**Subject:** USNRC 10CFR Part 21 Notification

**Ref:** Flowserve Size  $\frac{3}{4}$  Figure 848Y Disk/Disk Nut Separation  
LaSalle Station  
Exelon PowerLabs, LLC Project Number: LAS-62808  
Flowserve Complaint Report 4914  
Flowserve Evaluation Report No. 10 CFR 21-50

**Figure 1 Stem/Disk Assemblies for Old Design and New Design Figure 848 / A848 Valves.**

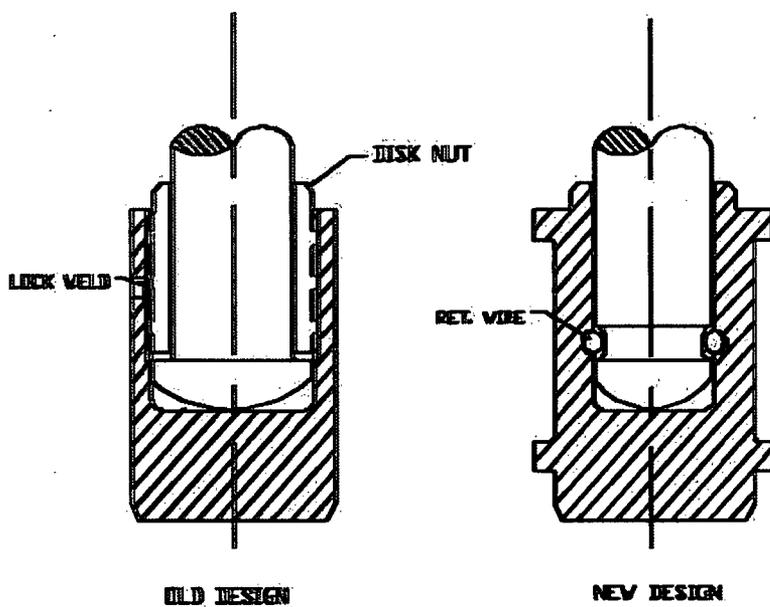
Figure 1 provides an illustration of the stem/disk assembly in the Size  $\frac{3}{4}$  Figure 848 valve. The **"Old Design"** is typical of the valve that is the subject of this discussion. The valve stem has a collar on the very end. After the stem is inserted into the disk, the disk nut is threaded into the disk to retain the stem. A lock weld is then created to prevent the disk nut from unthreading out of the disk.

For the case of the **"Old Design"** valve at LaSalle, once the disk nut has unthreaded out of the disk, the stem and the disk are no longer connected. The valve will then operate as a stop-check valve. The valve will open in response to normal forward flow, and close in response to normal reverse flow.

Because the disk nut is a solid piece assembled around the valve stem, the disk nut cannot fall off of the valve stem and become a loose part in the piping system.

After unthreading from the disk, the disk nut will sit on top of the disk. The valve will be able to open only partially, because the disk nut will interfere with the ability of the valve to open fully. The amount that the valve can open will depend on the size of the valve. For the Size ¾ valve at LaSalle, the disk would be able to open less than 1/8 of an inch. The amount that other valve sizes would be able to open is different, but all would be reduced.

The valves affected are Size 2 and smaller Edward Figure 848 valves manufactured by Rockwell International at the Sulphur Springs, Texas, and the Raleigh, North Carolina, manufacturing facilities prior to 1991. These valves may be tagged "Rockwell", "Rockwell Edward" or "Edward". The valves affected have the "**Old Design**" stem/disk assembly shown in Figure 1.

In about 1990, the design was changed to that shown as the **"New Design"** in Figure 1. The disk nut was eliminated, and the disk retained on the end of the valve stem using a piece of wire inserted into a groove located half in the valve stem and half in the disk.

Valves with Figure Number **A848** incorporate the "**New Design**" stem/disk connection and are not affected.
